ADDENDUM NUMBER: THREE

PROJECT: High School Exterior improvements – Phase 1
Johnston County Public Schools
601-A West Market Street
Smithfield, North Carolina 27577

PROJECT NO: 23028

DATE: October 30, 2023

Date	09/28/23	Project No.	23028
Drawn By	ABG	Sheet No.	A-A1.1
Checked By	AWC	Sheet Title	NORTH JOHNSTON HIGH SCHOOL SITE
Addendum #3 - 10/30/2023

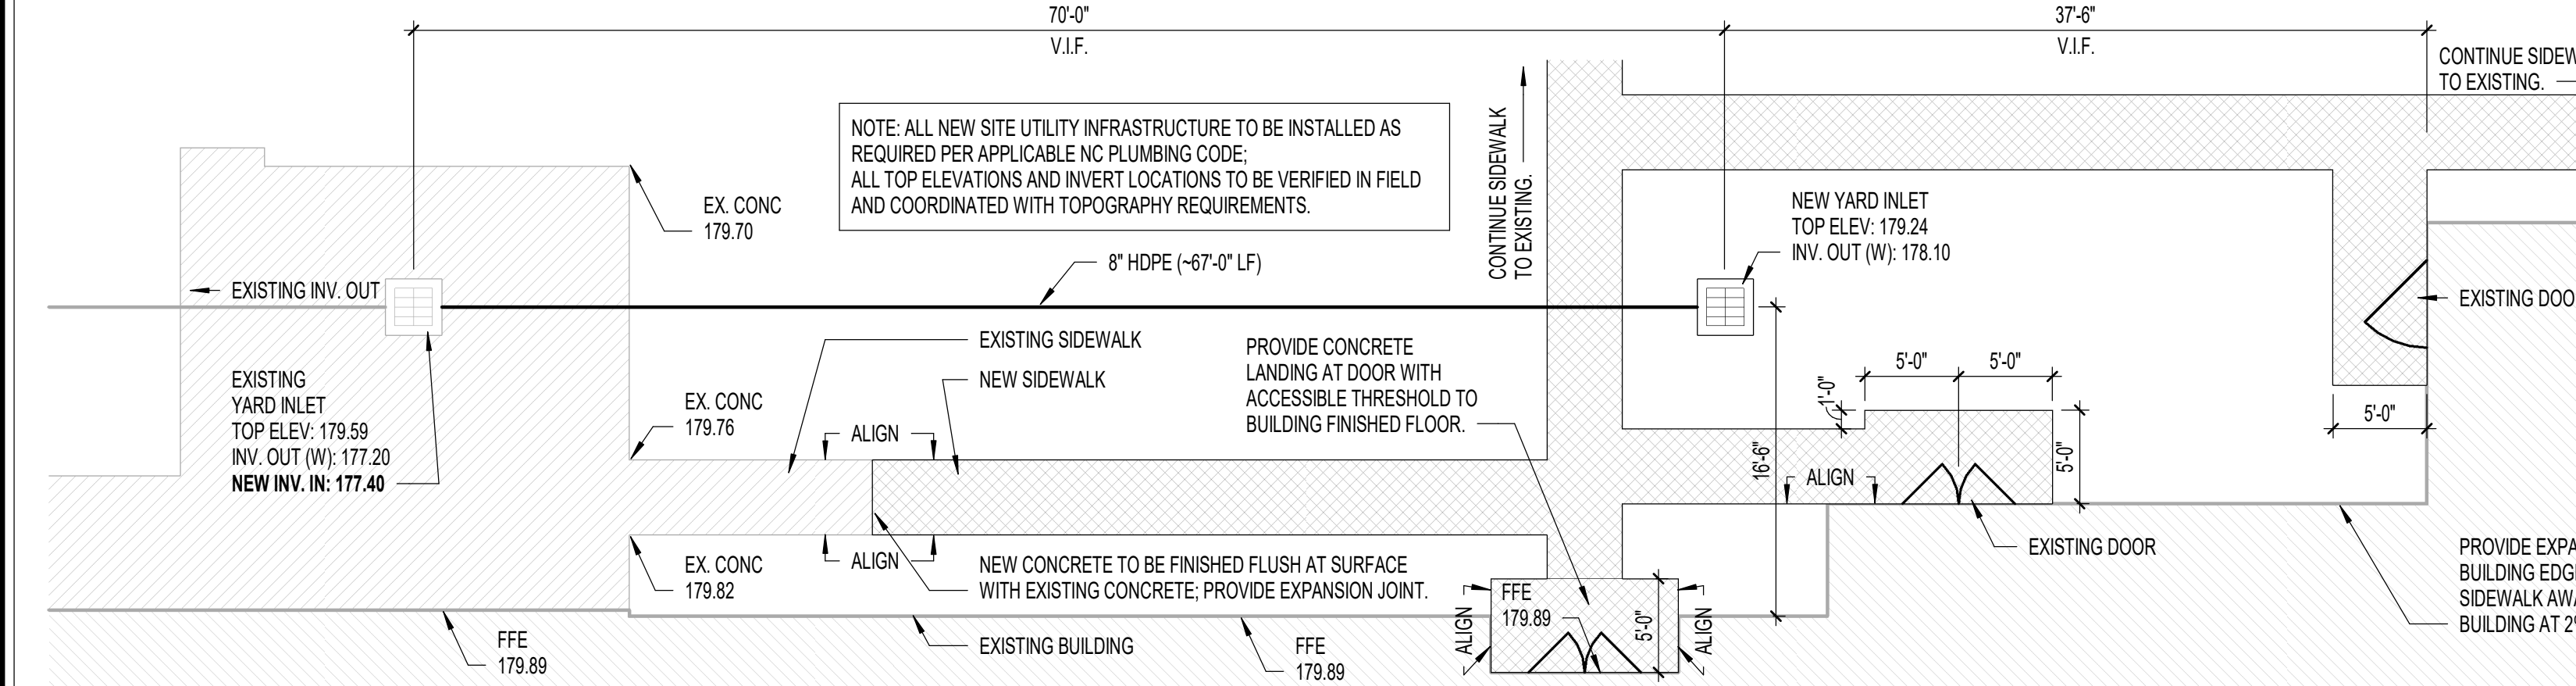
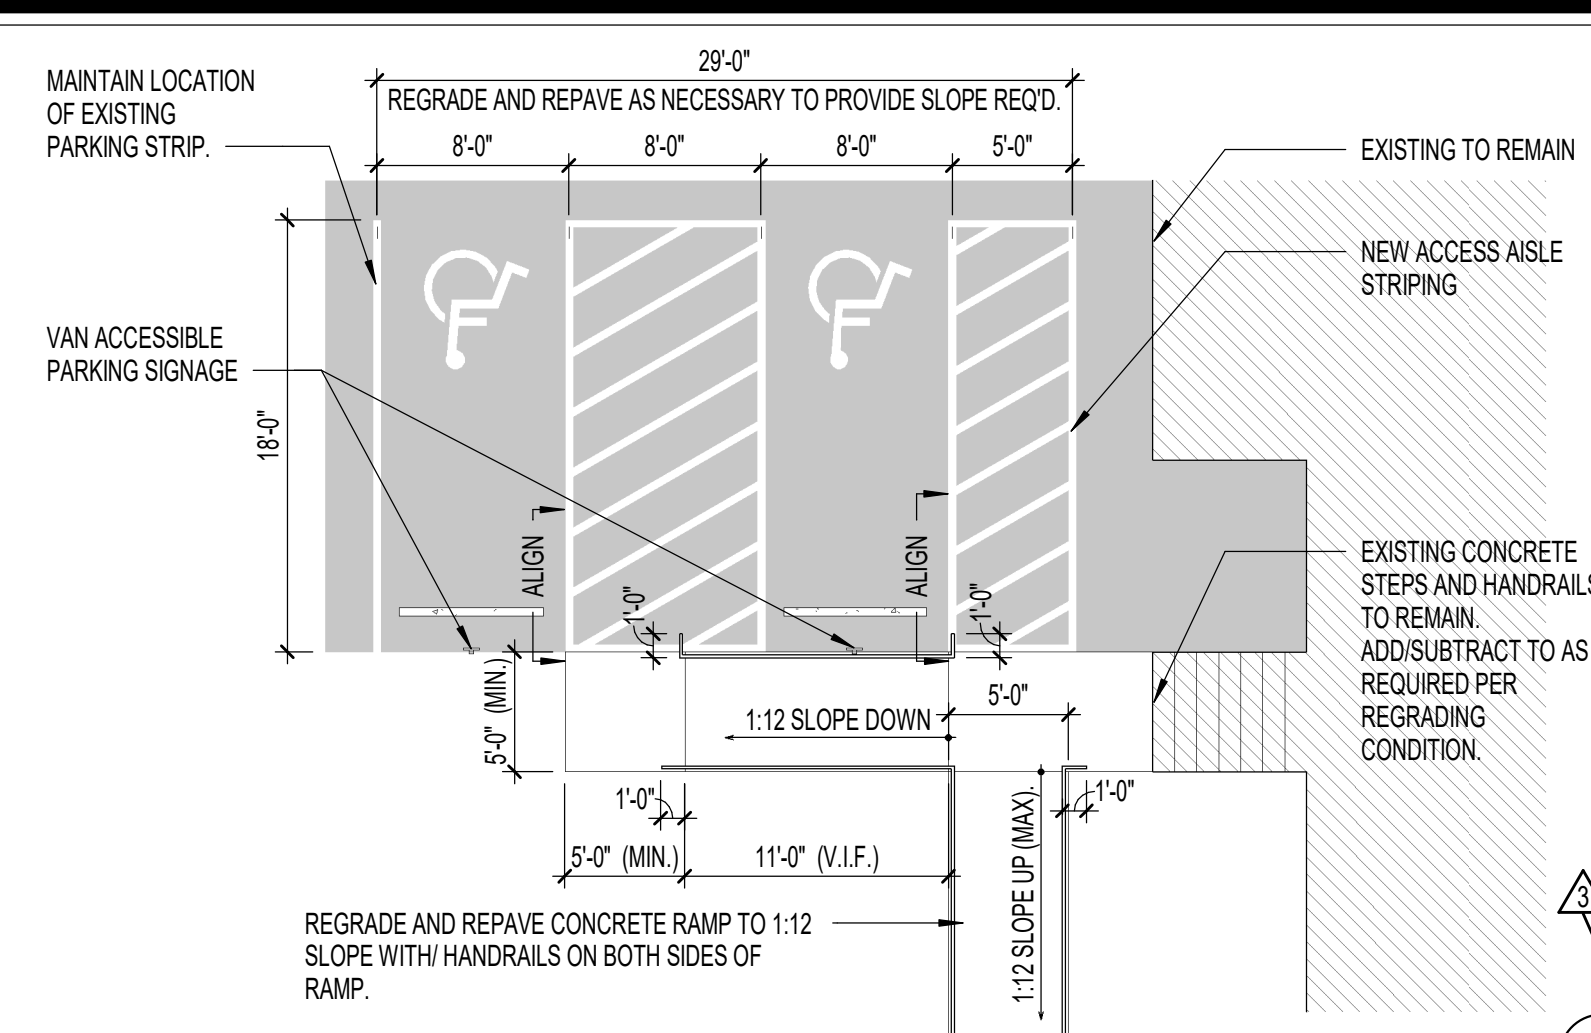
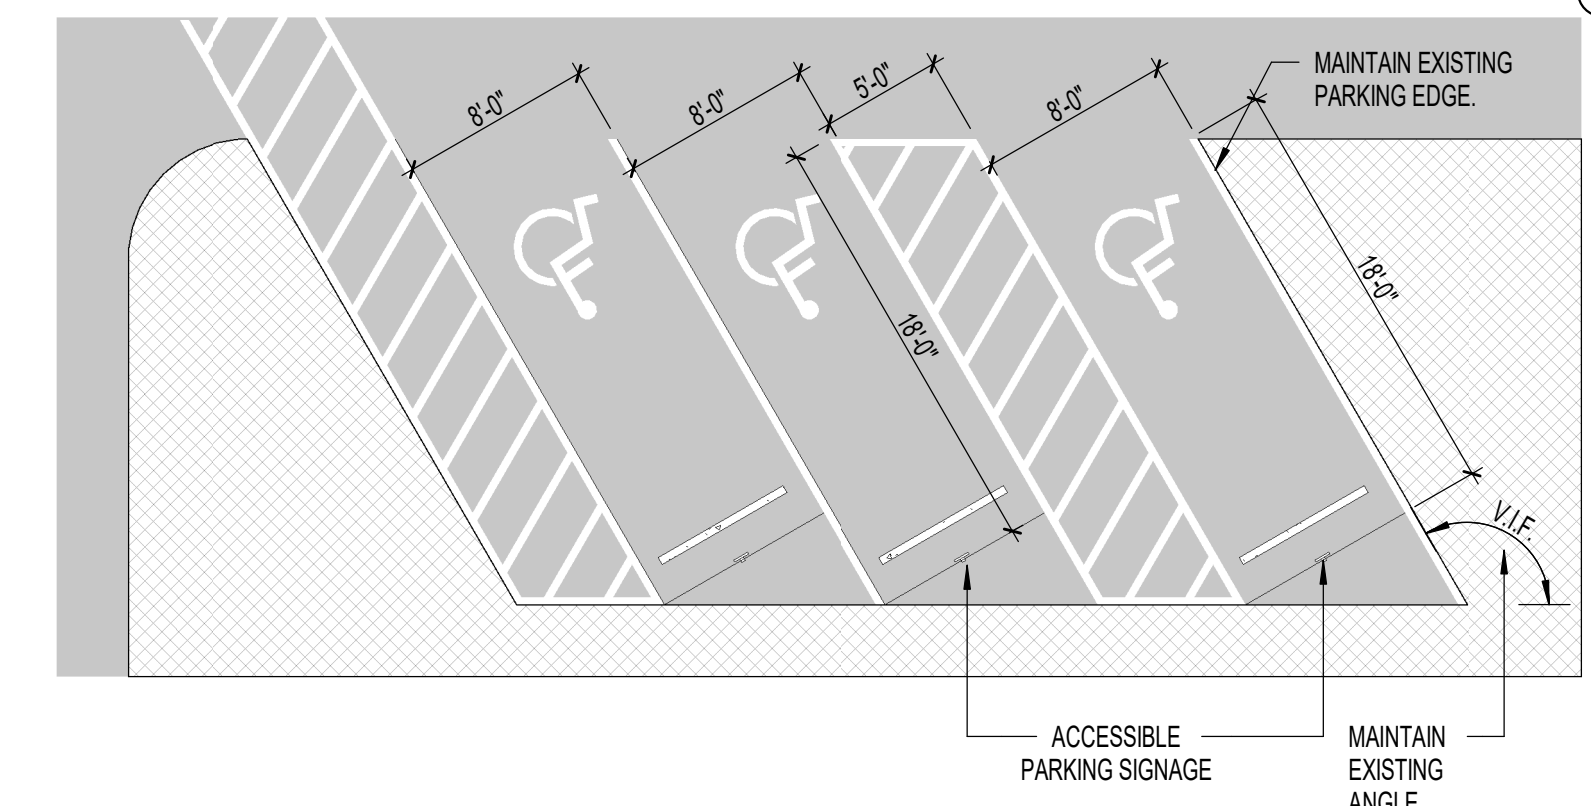
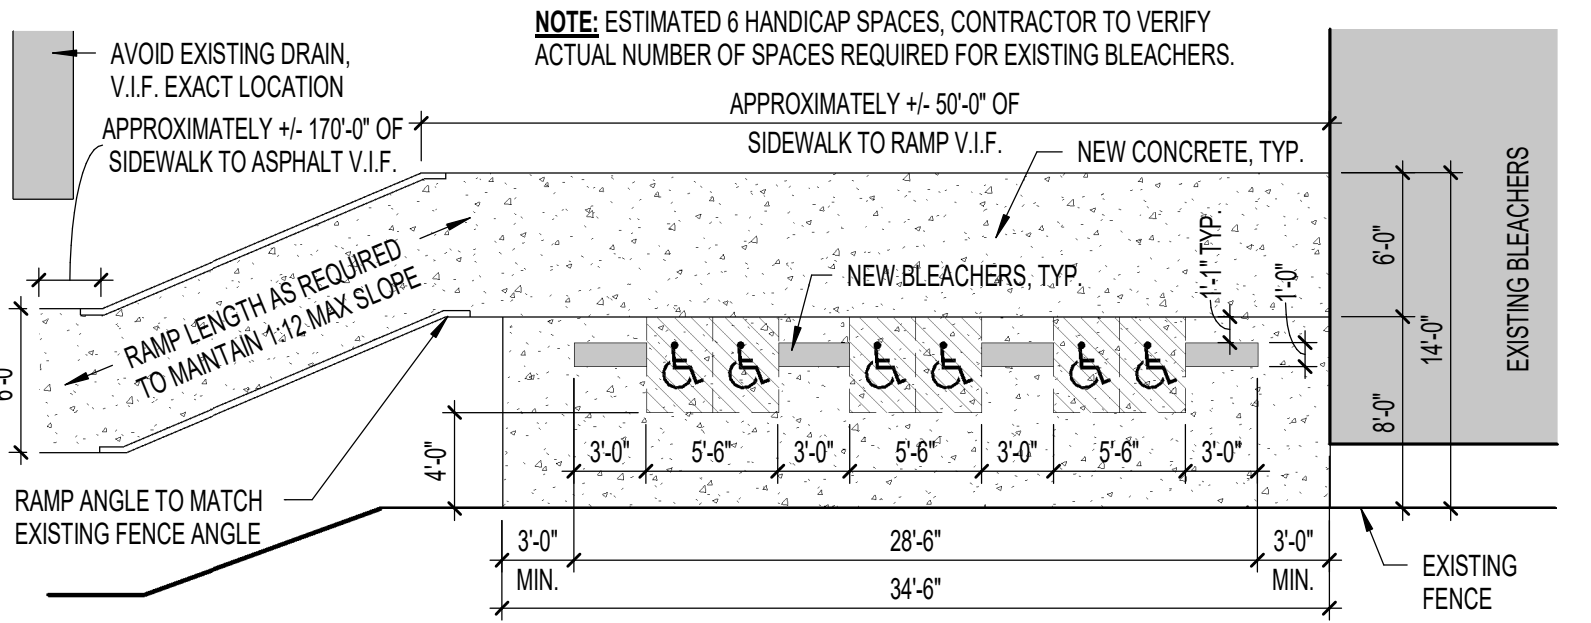
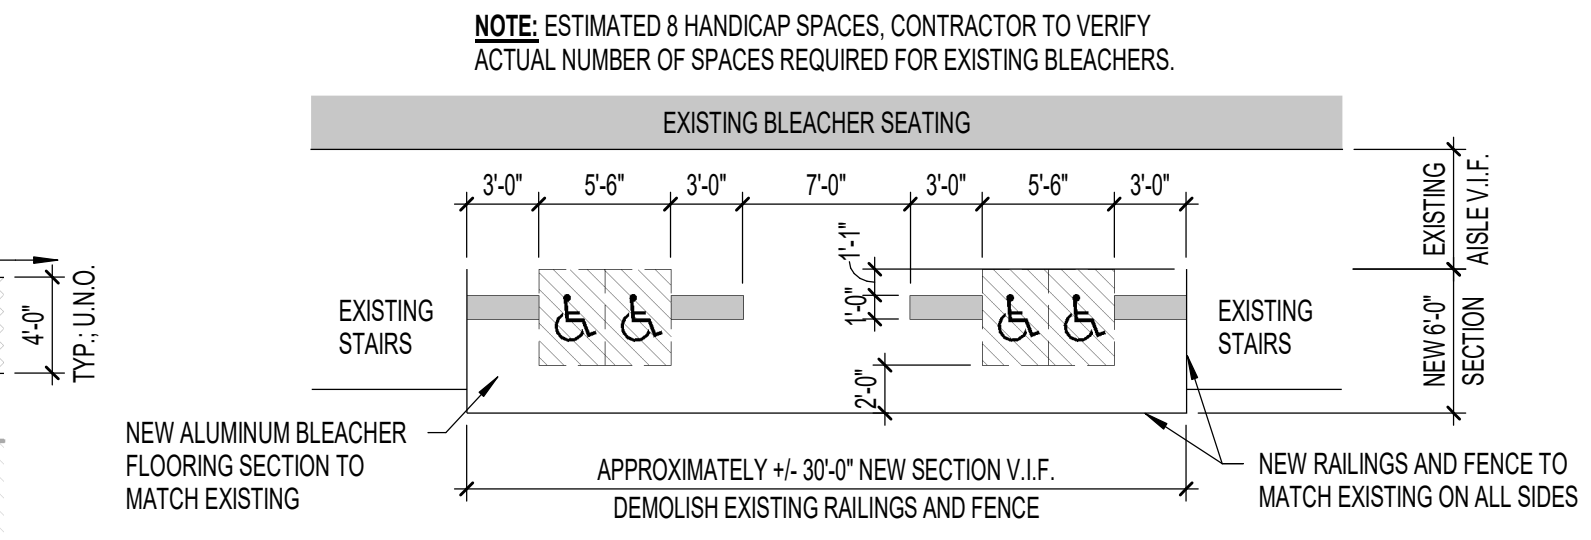
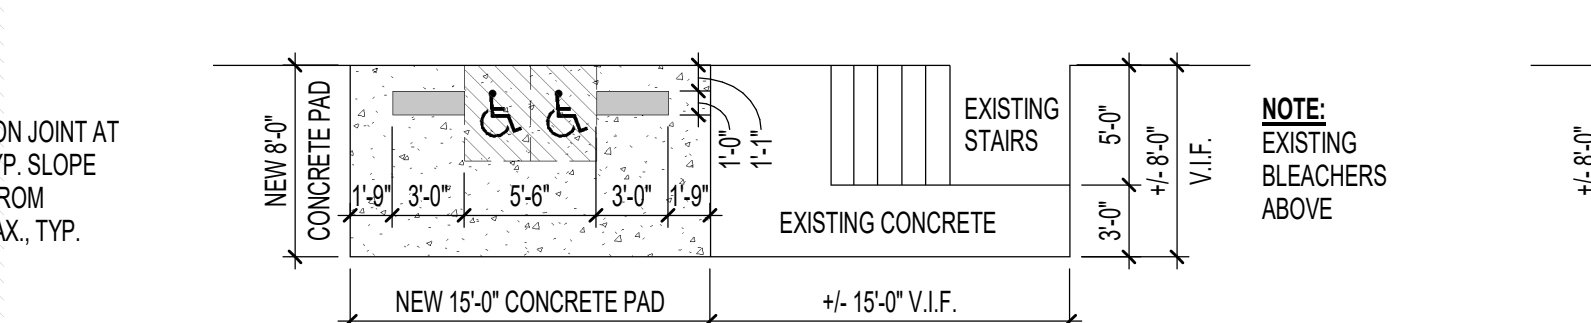
Sheets A-A1.1, A-A1.2, & A-A1.3 – North Johnston High School

Remove existing sheets in their entirety and replace with the attached sheets. Revised keynotes to reflect Bid Alternate G-1: Pre-manufactured Aluminum Ramps.

3. PROVIDE NEW PRE-MANUFACTURED ALUMINUM LANDINGS AND RAMP FOR EACH MOBILE UNIT ENTRANCE. AS REQUIRED, DEMOLISH EXISTING BOARDWALK AND REPLACE WITH ACCESSIBLE BOARDWALK WALKWAY AND A 5 FT. x 5 FT. LANDING AT THE BASE OF EACH RAMP WITH A FINISHED ELEVATION OF 30 INCHES (MAX.) BELOW EACH RESPECTIVE MOBILE UNIT DOOR THRESHOLD. BOARDWALK IS TO BE BUILT OUT OF P.T. LUMBER OF SIMILAR SIZE AND TYPE AS EXISTING. PROVIDE A NON-SLIP SURFACE AS REQUIRED. PROVIDE CONCRETE PAD FOR NEW LANDINGS AND RAMP. CONTRACTOR TO VERIFY SIZE OF CONCRETE PAD NEEDED IN FIELD. SEE ALTERNATE 6-1 FOR MORE INFORMATION.
